**HUGHES
SERVICE INFORMATION
NOTICE**

NOTICE NO. N-110

**SUBJECT: CONFIGURATION MODIFICATION - 2050 LB GROSS WEIGHT,
CONVERSION KIT NO. M10078**

MODELS AFFECTED: Model 269C Helicopter Serial No. 0004 thru 0209

Figure 1. Configuration Modification - 2050 Lb Gross Weight, Conversion Kit No. M10078

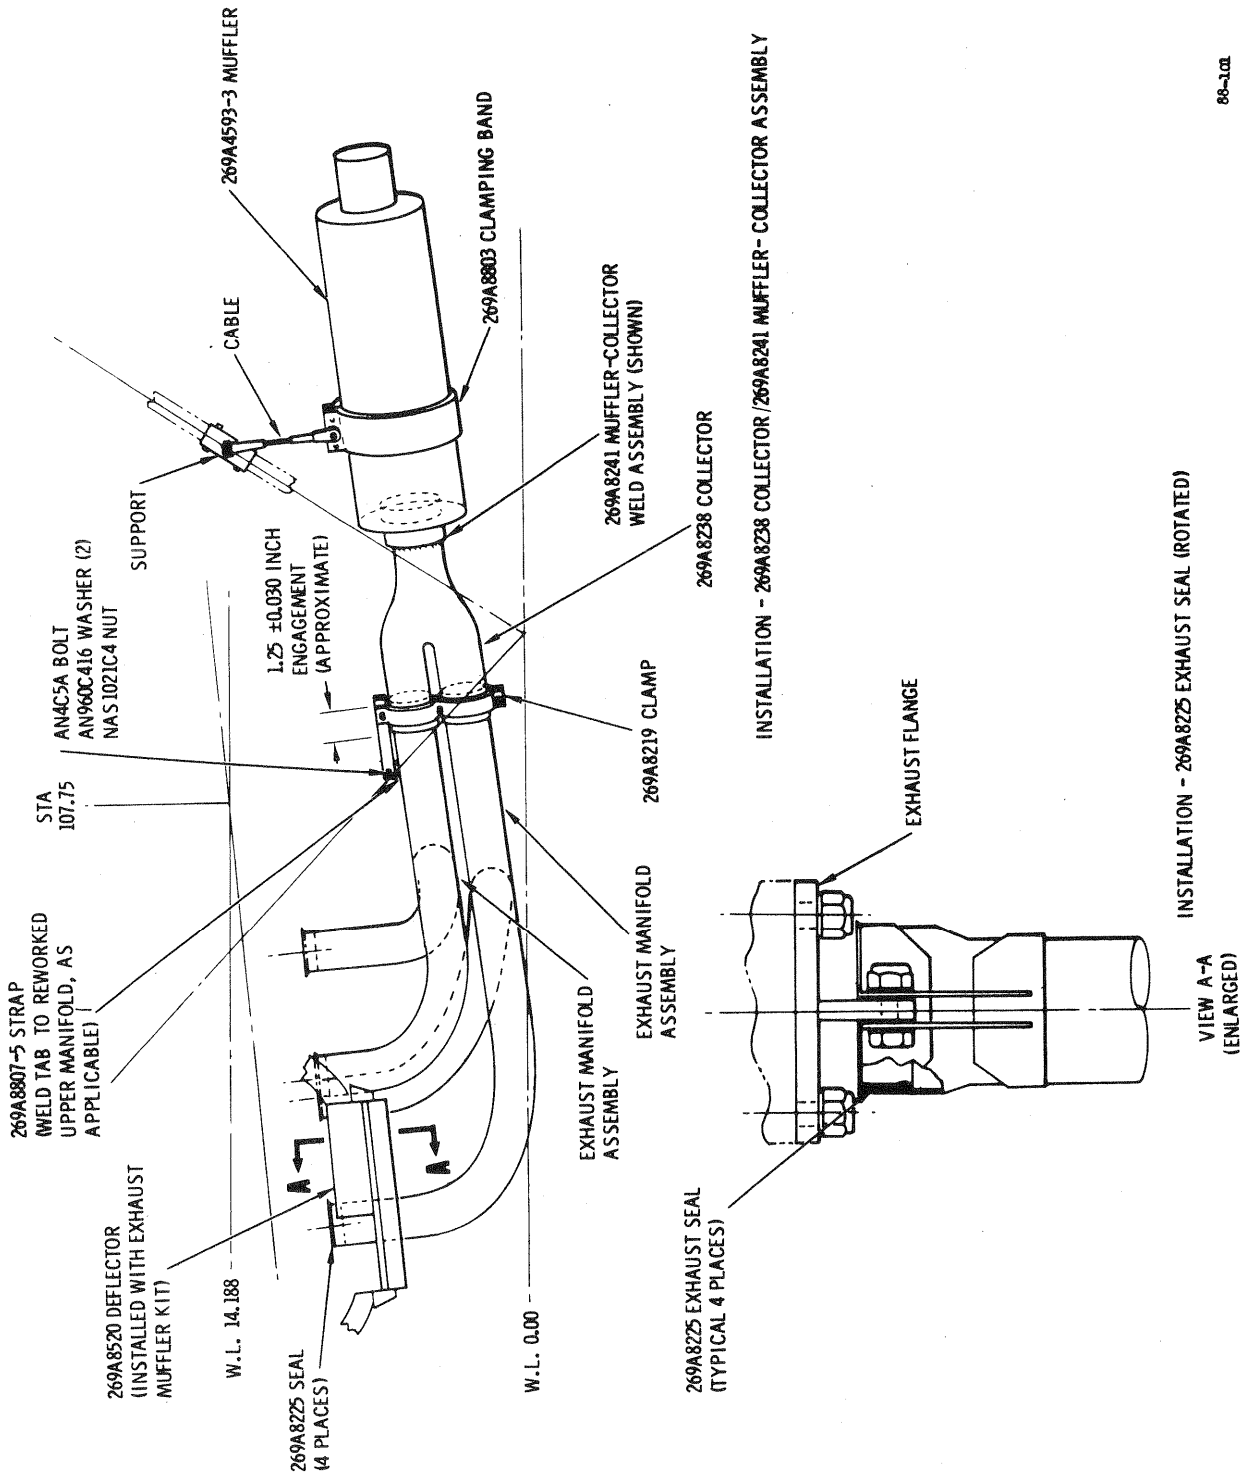
- (3) Shorten existing exhaust manifolds by cutting off 2.75 inches at aft ends. Remove tab from section of exhaust tube cut off and reweld on aft end of upper manifold, using #601 welding rod. Locate tab 2.75 inches from end and in line with 269A8219 clamp. Identify reworked #1 and #2 cylinder exhaust manifolds as M10078-3; identify reworked #3 and #4 cylinder exhaust manifolds as M10078-5.

- (4) Install new -61 or reworked exhaust manifolds on helicopter; install new 269A8225 seals as shown in View A-A of Figure 1. Also install 269A8224 cylindrical deflectors and clips, if exhaust muffler is to be used; refer to HMI Appendix A and exhaust muffler kit installation instructions.

- (5) If exhaust muffler is NOT to be used, install new 269A8238 collector at aft ends of exhaust manifolds as shown, using existing 269A8219 clamps.
- (6) If exhaust muffler is to be used, install new 269A8241 muffler-collector (or reworked muffler-collector as noted below) at aft ends of exhaust manifolds, using existing 269A8219 clamps.

- (7) Install 269A8807-5 strap to top of 269A8219 clamps, using existing hardware, and to tab on upper exhaust manifold using AN4C5A bolt, AN960C416 washer and NAS1021C4 nut.
- (8) Install exhaust manifold support cable from scroll mounting bracket to top of 269A8219 clamps.
- (9) If exhaust muffler is used, install 269A8803 band on muffler and secure to cable and support hardware attached to frame tube. Refer to HMI Appendix A and exhaust muffler kit installation instructions.
